Lead Local Flood Authority

RE: DC/26/0592 Land at Lower Broadbridge Farm Billingshurst Road Broadbridge Heath Horsham West Sussex RH12 3LR

This is a Reserved matters application for the erection of 133 dwellings following approval of outline application DC/22/1052 as amended by DC/25/1886, relating to appearance, landscaping, layout and scale.

(from drainage layout with watercourse marked in yellow)

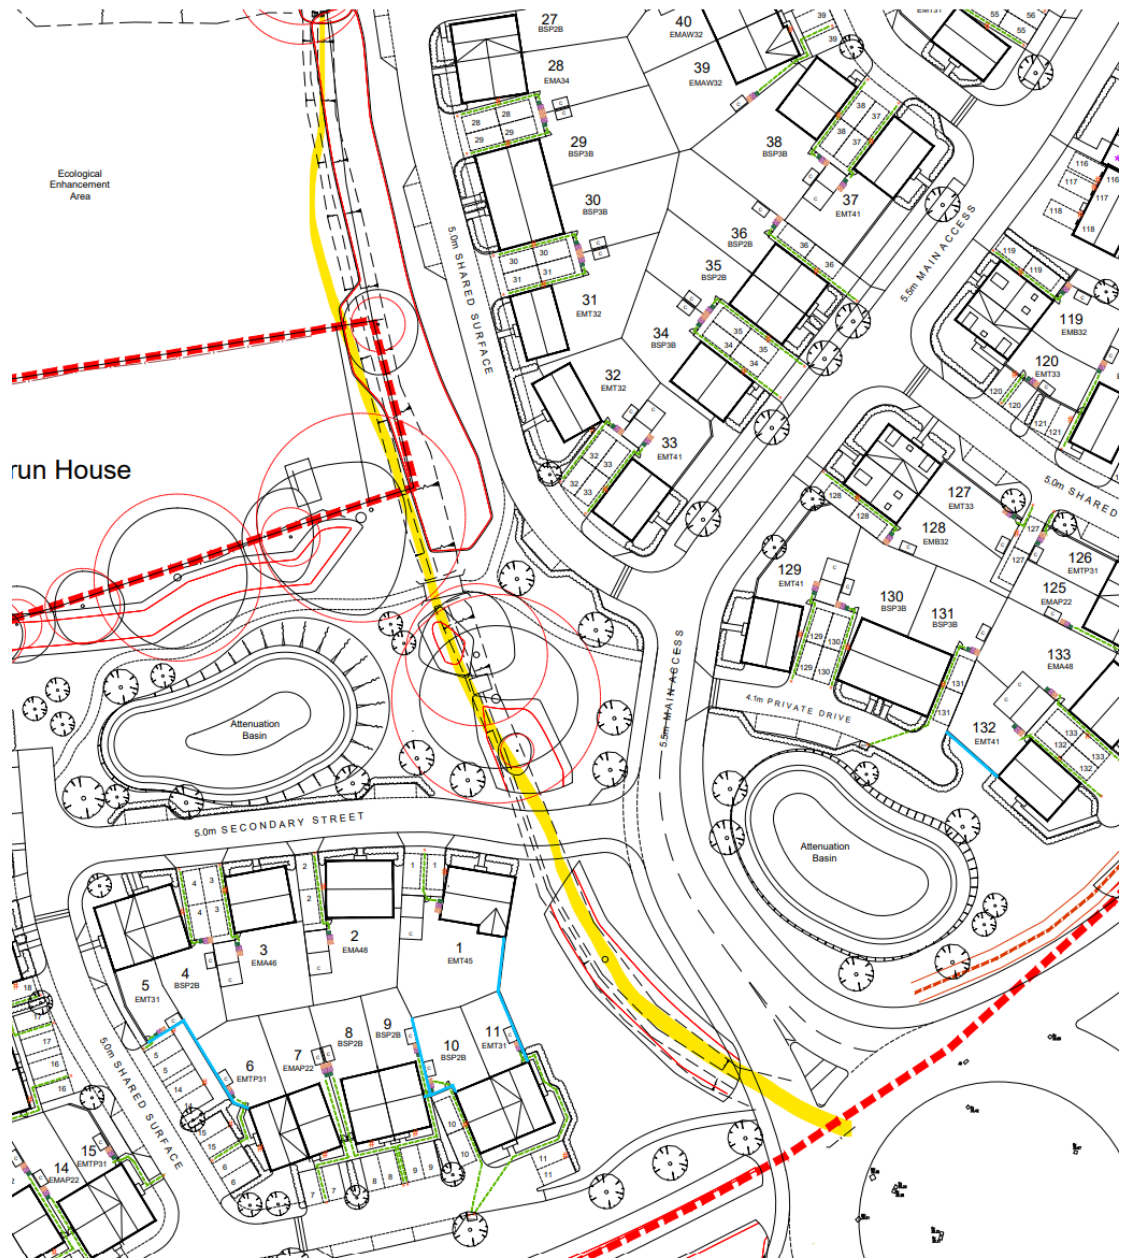
2. Please could we be provided with an updated drainage strategy layout, inclusive of the following. There appear to be a headwall to basin (S528) seemingly not in the bank, and the discharge headwall for this basin may be outside the redline boundary:

- a. A 3m easement buffer illustrated for each watercourse bank top and attenuation basin bank top.
 - b. Hard bed levels for all watercourses on site
 - c. Confirmed headwall locations with invert levels and labelling confirming right to utilise the bank if outside the redline boundary

- e. An exceedance route plan (this can be a separate document if required)
 - f. We also note there will be amendments to the existing watercourse, please ensure the plan includes the updated course as proposed:
